Access Compliance Report Public Rights-of-Way (Curb Ramps)

Main Street: N/A	Cross Street: NARROW_CANYON_RD	Location: SE
------------------	--------------------------------	--------------

ADA ID: RPRK211115131420	Ramp Type: Type 4 - Parallel	Initial Pass/Fail: Fail	Overall Compliance: No	Severity Score: 2
--------------------------	------------------------------	-------------------------	------------------------	-------------------

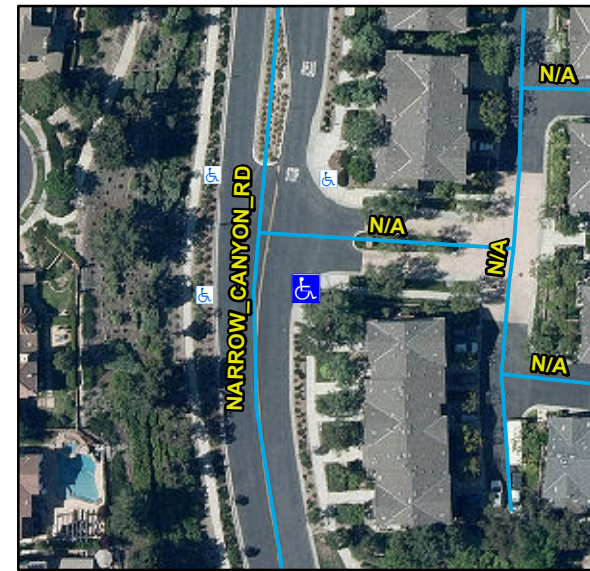
Compliance	Description	Data	Compliance	Description	Data
N/A	Ramp Length LT (in)	121	N/A	Ramp Length RT (in)	132
Yes	Ramp Width LT (in)	90	Yes	Ramp Width RT (in)	89
Yes	Ramp Run Slope LT (%)	6.8	Yes	Ramp Run Slope RT (%)	1.5
No	Ramp Cross Slope LT (%)	2.8	No	Ramp Cross Slope RT (%)	2.4
N/A	Landing Present	N/A	N/A	DWS Provided	N/A
N/A	Landing Length (in)	N/A	N/A	DWS Contrast	N/A
N/A	Landing Width (in)	N/A	N/A	DWS Length (in)	N/A
N/A	Landing Run Slope (%)	N/A	N/A	DWS Full Width	N/A
N/A	Landing Cross Slope (%)	N/A		DWS Offset Type	N/A
N/A	Landing Movement Obstructed?	N/A	N/A	DWS Offset Left (in)	N/A
	Landing Movement Type	N/A	N/A	DWS Offset Right (in)	N/A
N/A	Landing Shared	N/A			
N/A	Clear Space	Yes			
N/A	Clear Space To Crosswalk (in)	N/A			
N/A	Marked Crosswalk 1	No	N/A	Marked Crosswalk 2	No
	Crossing 1 Direction	N		Crossing 2 Direction	W
N/A	Marked Crosswalk 1 Width (in)	N/A		Marked Crosswalk 2 Width (in)	N/A

N/A	Ramp Inside Crosswalk 1	N/A	N/A	Ramp Inside Crosswalk 2	N/A
	Crossing 1 Slope (%)	3.5		Crossing 2 Slope (%)	4.1
	Crossing 1 Cross Slope (%)	1.5		Crossing 2 Cross Slope (%)	2.6
N/A	Gutter Ponding	N/A	N/A	Curb Slope	8.3
Yes	Gutter Lip Height (in)	0		Road Run Slope (%)	2.1
N/A	Gutter Run Slope (%)	N/A		Road Cross Slope (%)	5.4
N/A	Gutter Cross Slope (%)	N/A	No	Perpendicular Joint Present	No
Yes	Overall Surface Condition	Acceptable			
	Cross Gutter Present?	No		Spandrel Present?	No
	Replace Cross Gutter?	N/A		Replace Spandrel?	N/A

Remove & Replace Curb Ramp With Two New Directional Ramps or Equivalent.
